DATE: June 16, 1958
SUBJECT: Review of the ORR Shield for 30-Mw Operation
TO:
FROM: Walter Zobel, E. G. Silver, and T. V. Blosser

The proposed shield for the Oak Ridge Research Reactor was reviewed for a reactor power of 30 Mw. It was concluded that the shield is more than adequate for this power providing the shield is augmented at the experimental facilities.

REVIEW OF THE ORR SHIELD FOR 30-Mw OPERATION

Figure 1

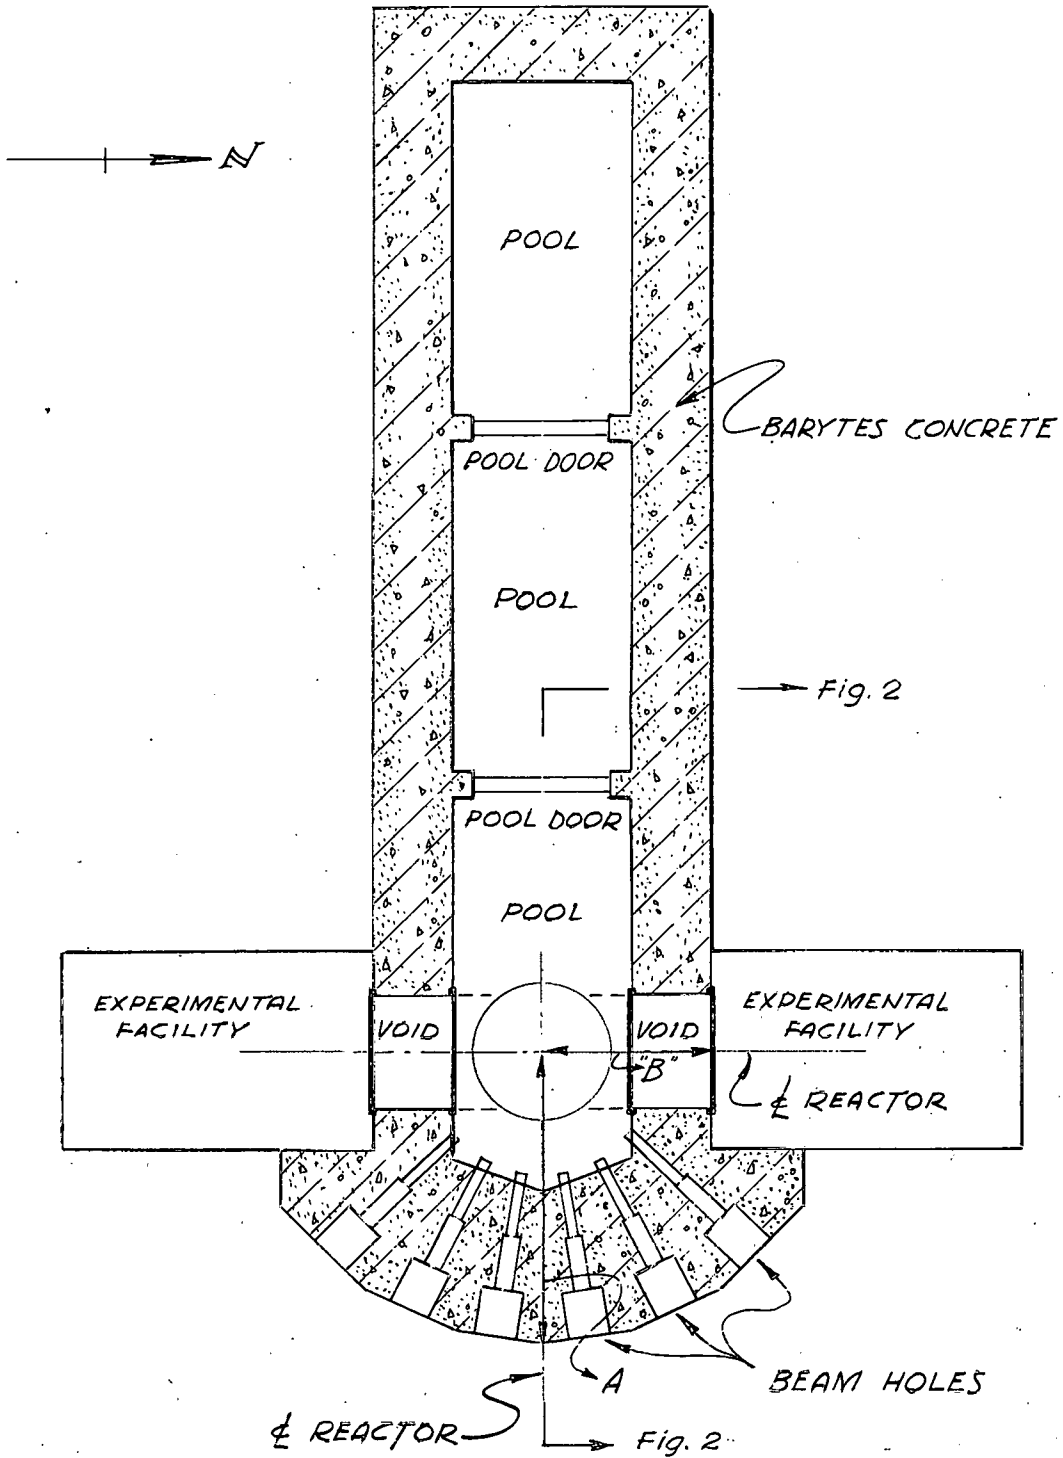
Each position of the following estimate is shown in Figs. 1 and 2 and the data for each position is summarized in Table 1.

A. Estimate of the Dose on the East Face of the Reactor Shield

It is assumed that the beam holes are filled with shielding equivalent to that of the surrounding reactor shield and that the attenuation of the aluminum ducting in the water portion of the shield is negligible.

Figure 2

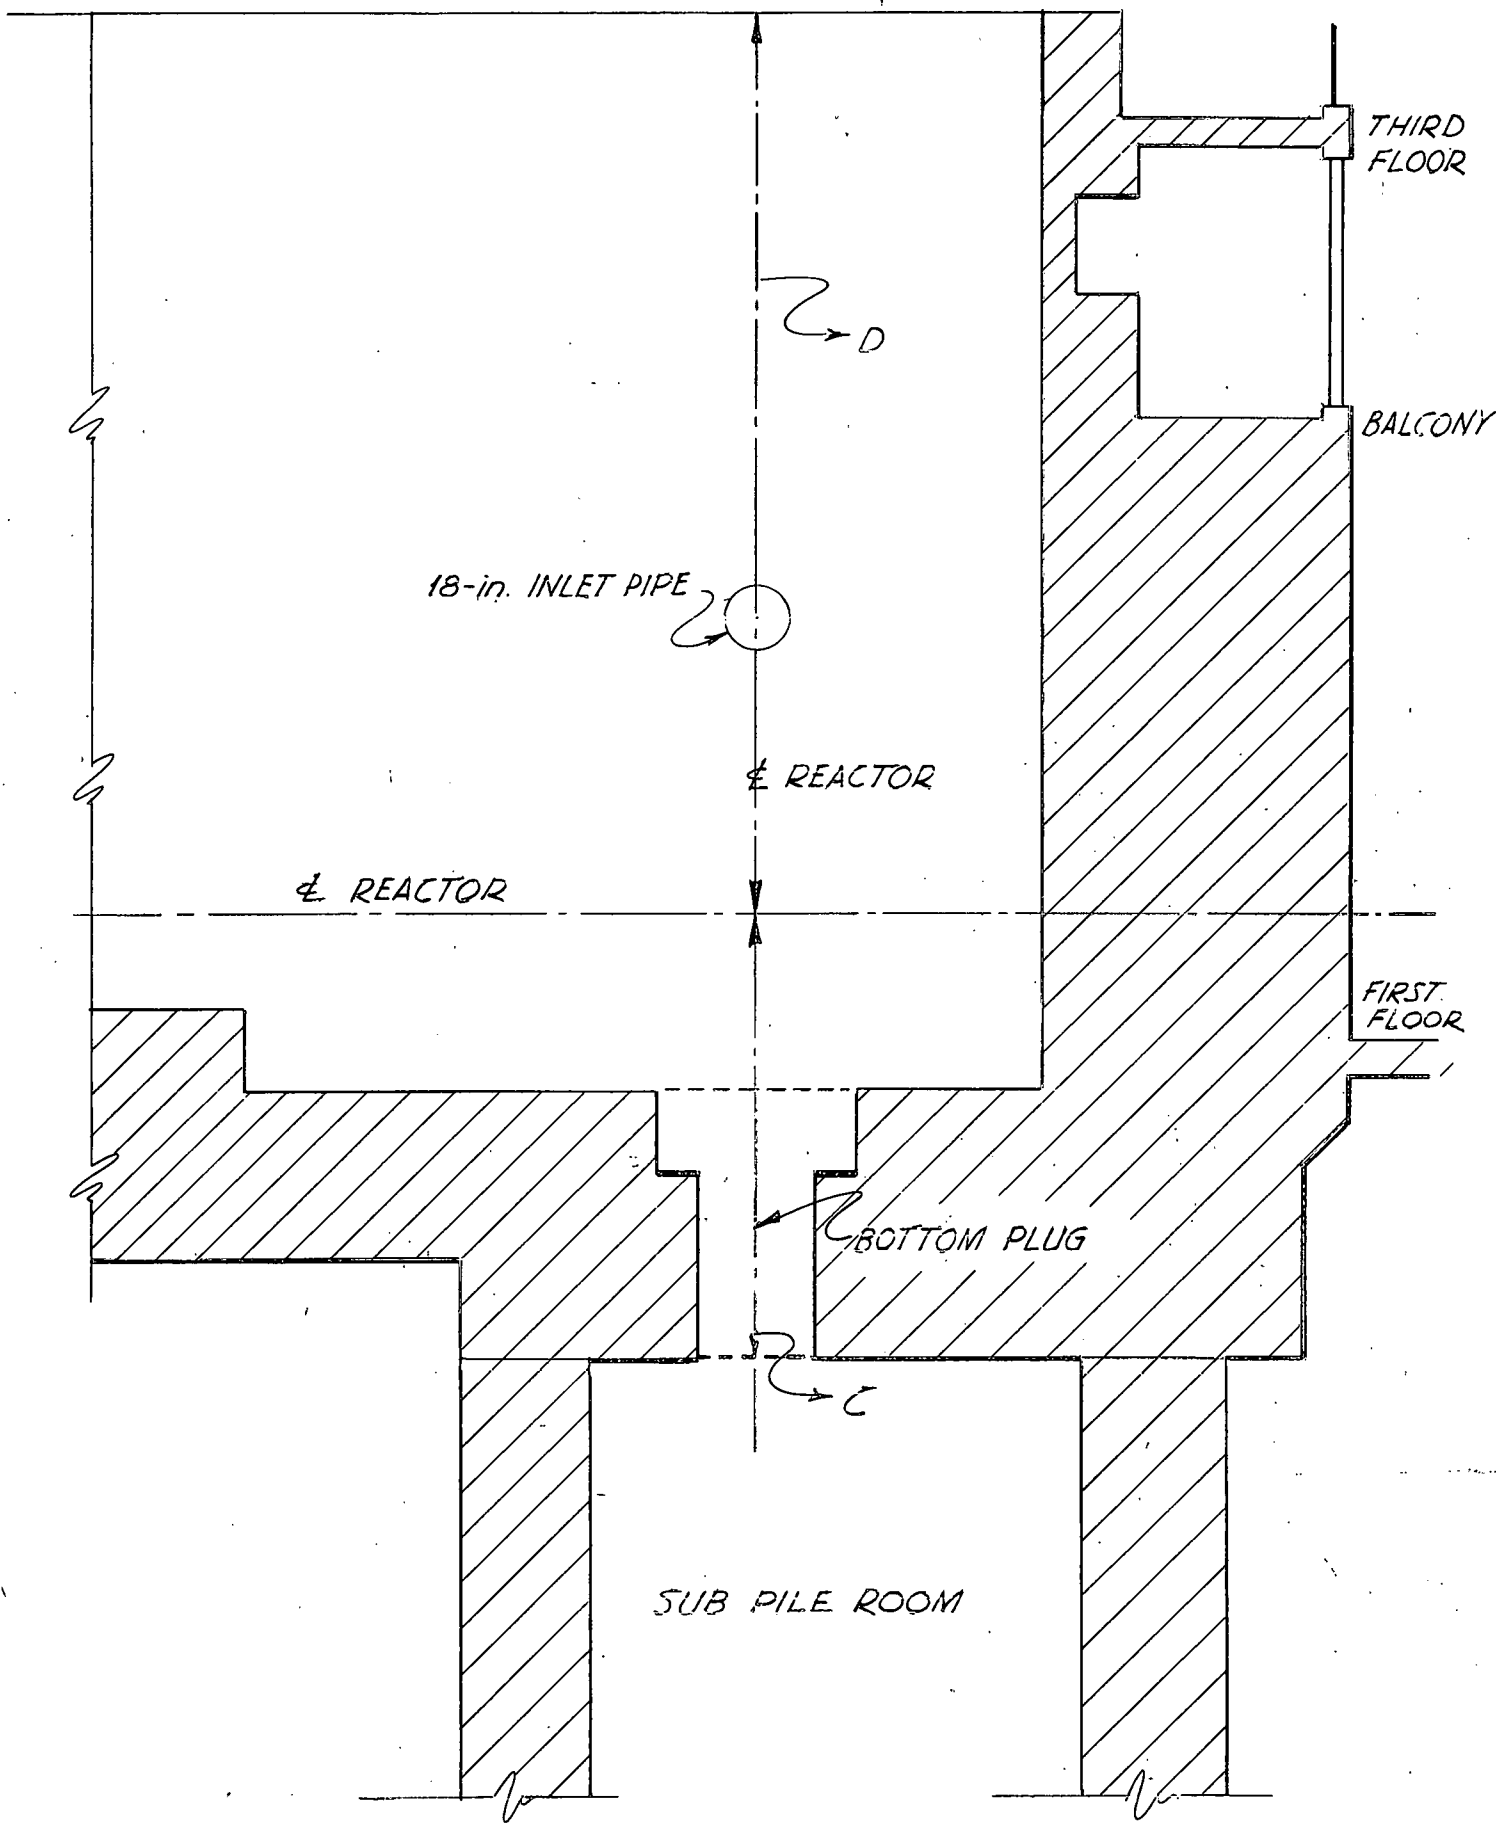
As shown in Appendix A, the dose in the room below the reactor (see Fig. 2) is practically impossible to calculate owing to the streaming down the rod openings. The ORR design group has indicated that they are willing to accept a higher dose in this area because there is again no need for personnel to remain in this room for long periods of time with the reactor at 30 Mw, and a door will be provided to shield the entrance to this room if necessary.

Obviously the bottom plug is over-shielded, but since the reactor control rods pass through the bottom plug the largest contribution to the dose in the subpile room will be from the streaming around the control rods and through the adjacent concrete.

This flux is approximately a factor of 10 above the tolerance level. In order to obtain the dose below the plug, it was assumed, from age displacement, that the thermal-neutron flux has the same relaxation length as the fast-neutron flux. The flux level thus obtained is 3×10^{-4} neutrons/cm²·sec.

Fig. 3. Relative Locations of ORR Coolers and Bldg. 3010.

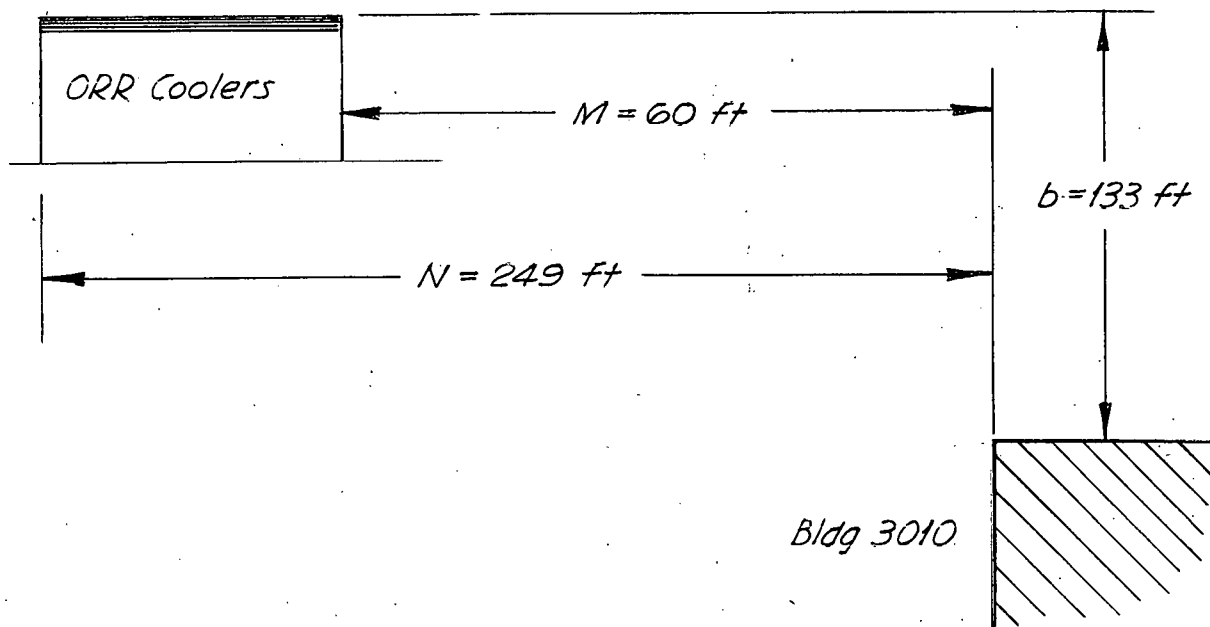
3. There will be a contribution to the dose rate at Bldg. 3010 due to the heat exchanger. This is calculated with all factors the same except for the integral representation of the geometry. The integral becomes:

where the geometry is shown in Fig. 3 and

0.072 mr/hr under normal conditions with self attenuation,
0.149 mr/hr with self attenuation and demineralizer failure.

Fig. 4. Relative Vertical Positions of ORR Pump House, Pump House Shield, and Bldg. 3010.

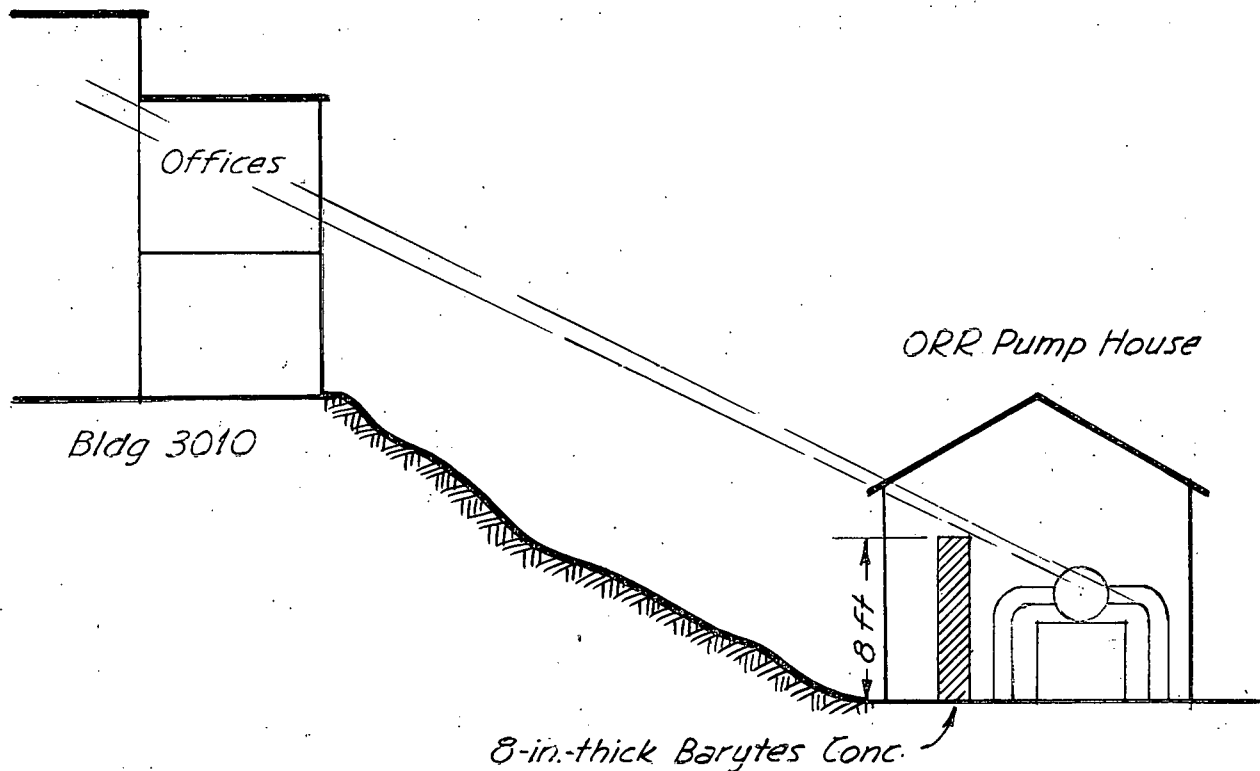
1. The dose rate due to the pump house varies, depending on the location in Bldg. 3010 (BSF) since part of the second floor of this building is not shielded by the 8-in. barytes concrete wall of the pump house. This situation arises because the shielding wall is only 8 ft high, and the pump house is so much lower than Bldg. 3010 that some radiation streaming over this wall can reach the second floor of Bldg. 3010 (see Fig. 4). Allowing for shielding through 8 in. of barytes and a distance of 100 ft, the dose from the pump house is 0.105 mr/hr. On the second floor, assuming 1/3 of the pump house liquid to be exposed over the wall, the dose rate due to the pump house is 0.34 mr/hr.

At the exterior pump house wall, assumed to be 10 ft from the pumps, considered as point sources, one gets a dose $100^2/10^2 = 100$ times as great as that computed at Bldg. 3010 (100 ft away) or 10.5 mr/hr. Since, however, the radiation is largely self-shielded and is not a point source, a factor of 1/2 is considered conservative, yielding 5.2 mr/hr.

It should be noted that, even under normal conditions, it would be hazardous to work on the roof of the pump house or to enter the pump cells for extended periods.
